## **Re: Defect Information Report – Supplemental Report No. 4 07V-212, FL-496, TBB Warning Light Malfunction**

Subject: RECALL 07V-212 – Saf-T-Liner C2 Door Switch

SUBJECT: IMPROVED AIR DOOR CONTROL OPERATION

BULLETIN: 13R

Figure 6

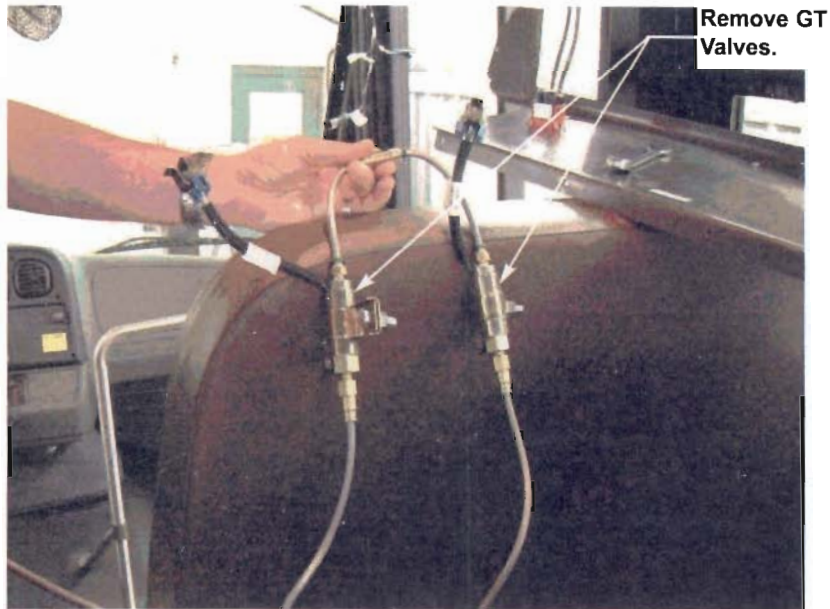
2. **If your unit is equipped with the GT Valve, perform the remainder of this bulletin. (Figure 6) These changes affect units with start date of 4/18/06 through 5/14/07.**

Figure 9

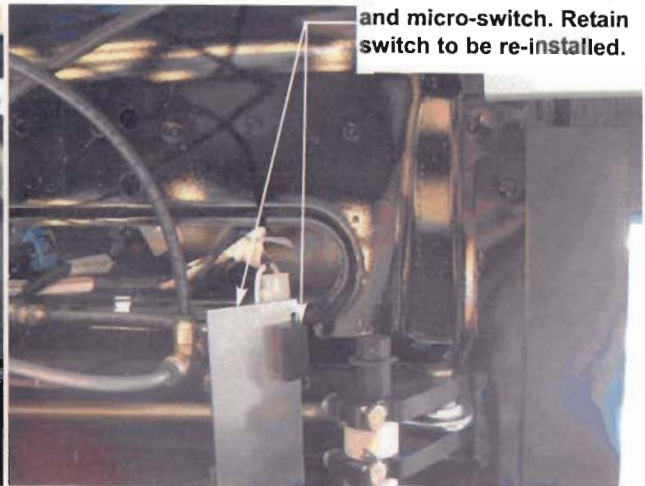
- 2.3 Remove solenoid valves. **Figure 1 and Figure 9**  
2.4 Remove existing switch bracket and micro-switch. **Figure 10**

Remove GT solenoid valves

Figure 10

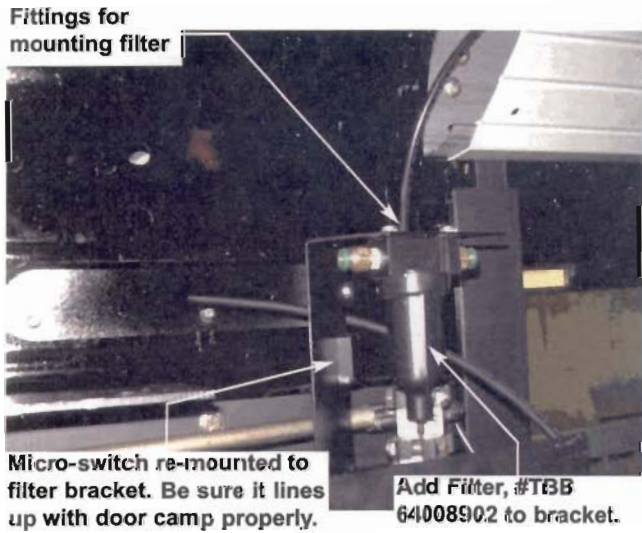
Remove switch bracket and micro-switch. Retain switch to be re-installed.

Figure 11

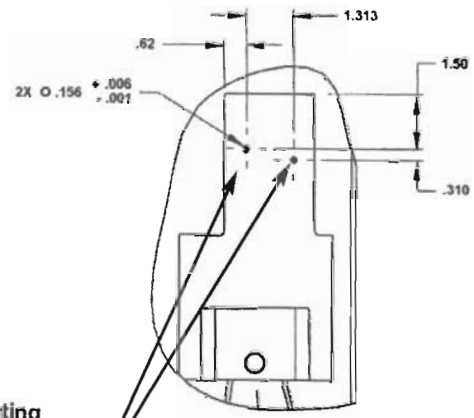
- 2.5 Re-assemble micro-switch to Filter Bracket, #TBB 116536. **Figure 11**
- 2.6 Attach Inline Air Filter, #TBB 64008902 and #8 Flatwasher, #TBB 69004271, #8 Lockwasher, #TBB 61370346 and Machine Screw, #8-32 x .50, #TBB 61370396. **Figure 11**
- 2.7 After you have removed the valve assembly as shown in **Figure 1**, drill new holes in the mounting plate to accommodate the Parker Valve Assembly, #TBB 136969. **Figure 12**

Micro-switch re-mounted to filter bracket. Be sure it lines up with door camp properly.

Add Filter, #TBB 64008902 to bracket.

Figure 12

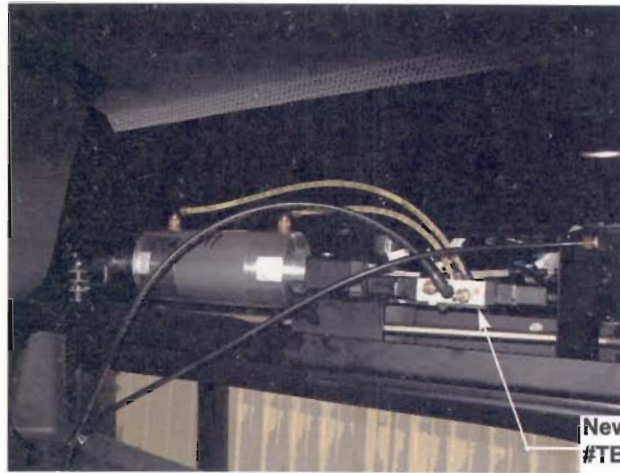
New mounting locations for Solenoid Valve, #TBB 136969.

TOP VIEW  
DRILL PATTERN  
SOLENOID VALVES REMOVED  
FOR CLARITY  
SCALE 0.375

Figure 14

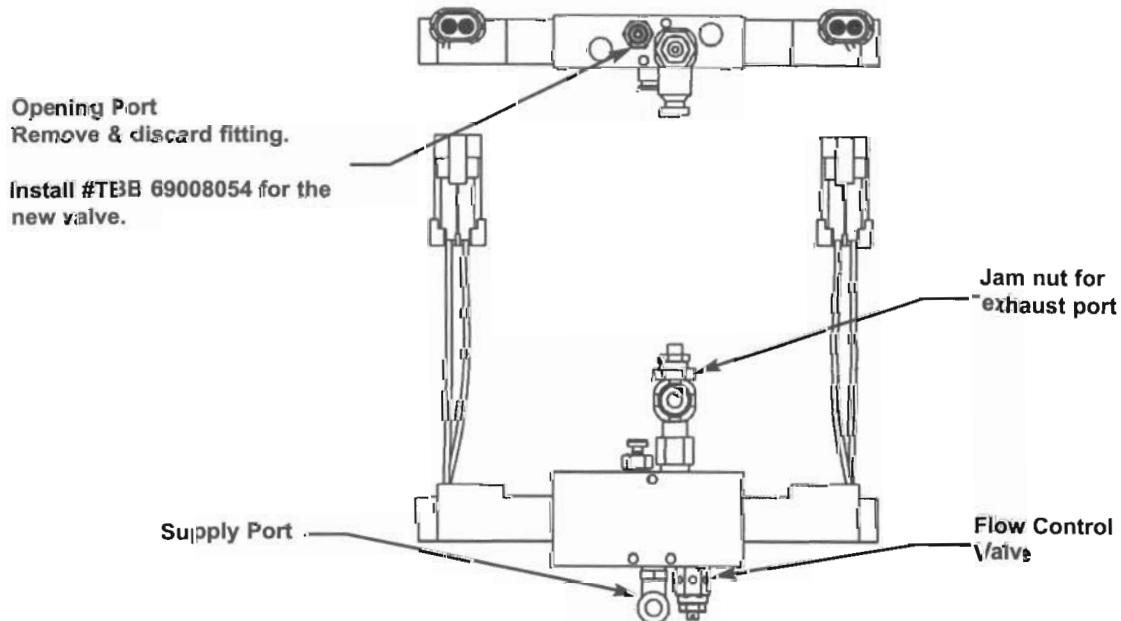
- 2.8 Assemble new Solenoid Valve, #TBB 136969 using Machine Screw, 6-32 x 1.25, #TBB 69002253 and Nylon Locknut, 6-32, #TBB 69004247. **Figures 13 & 14**
  - a. Remove the Opening Port fitting, and discard.
  - b. Install new Elbow Fitting #TBB 69008054 for the new valve to accommodate the 1/4 tubing.

New Solenoid Valve Assembly,  
#TBB 136969

Figure 2

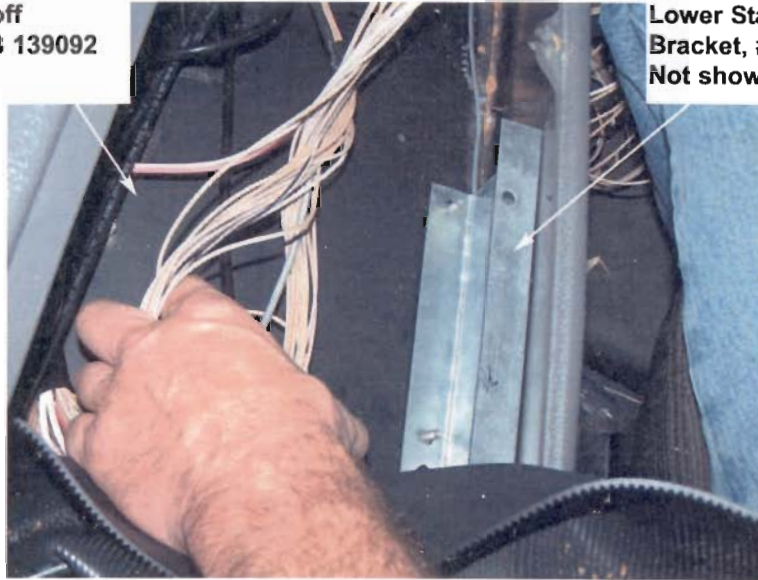
6. Install the Upper Stand-off Bracket, #TBB 139092 and Lower Stand-off Bracket, #TBB 139093 using existing fasteners removed in Step 4. Figure 2

Figure 4

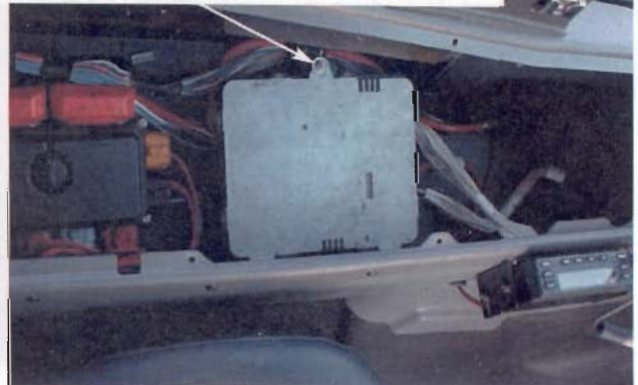
7. Reconnect the connectors to the SHM. See Figure 3 shows the original orientation of the SHM.
8. Rotate module 180°, installing it upside down with connectors face down, using Hex Flange Bolt, #TBB 29890014 and Hex Nut, #TBB 105826. Figure 4 shows new orientation of SHM.
9. Reinstall the rubber flap which was removed in Step 3.
10. Reinstall switch panel and harness.

New orientation for SHM  
Hex Flange Bolt, #TBB 29890014,  
Serrated Flange Hex Nut, #TBB 105826

Figure 7

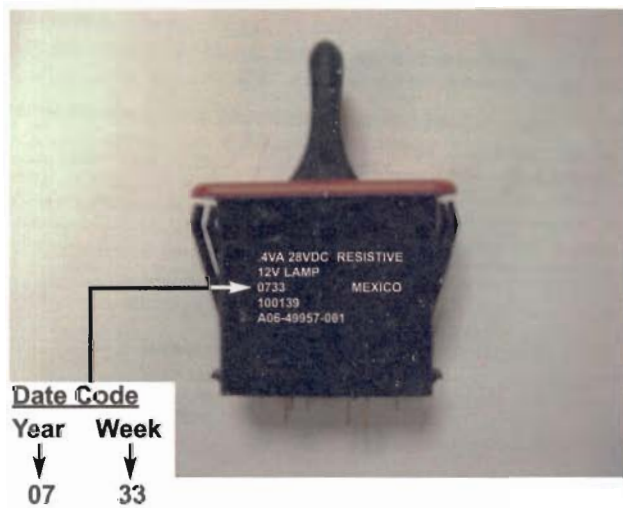
**Note:** If door switch Date Code is pre-September, 2006 (0636), switch must be replaced. See Figure 7 for an example of switch and location of the date code. Any switch with a Date Code prior to 0636 needs to be replaced, i.e. 0635, 0634, etc. Also, be aware that not all switches have the Date Code printed on the side as shown in Figure 7. Some of the early switches are 'engraved' on the front side (narrow side) of the switch on the "DOOR OPEN" end.

Figure 10

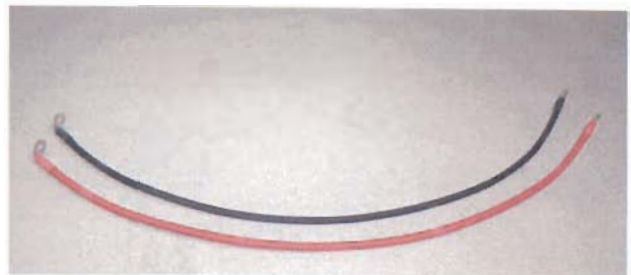
6. Remove cable from the vehicle to begin the following modifications. (Figure 9) **Note: Stock cable has the power and ground wire bundled together.**
7. Remove and discard the convoluted tubing from the cable bundle to separate the power and ground cable as shown in Figure 10.

Figure 13

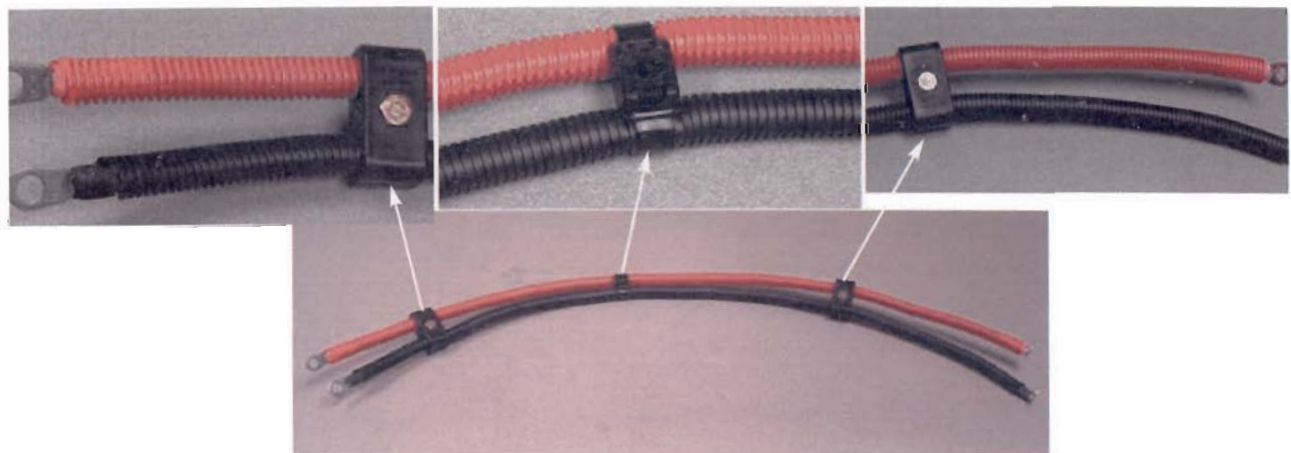
9. Install two (2) Dual Cable Clamps, TBB 61371384 and one (1) Dual Tie Wrap, TBB 61371394 as shown in **Figures 12 and 13**. See overview of completed cable assembly in **Figure 13**.
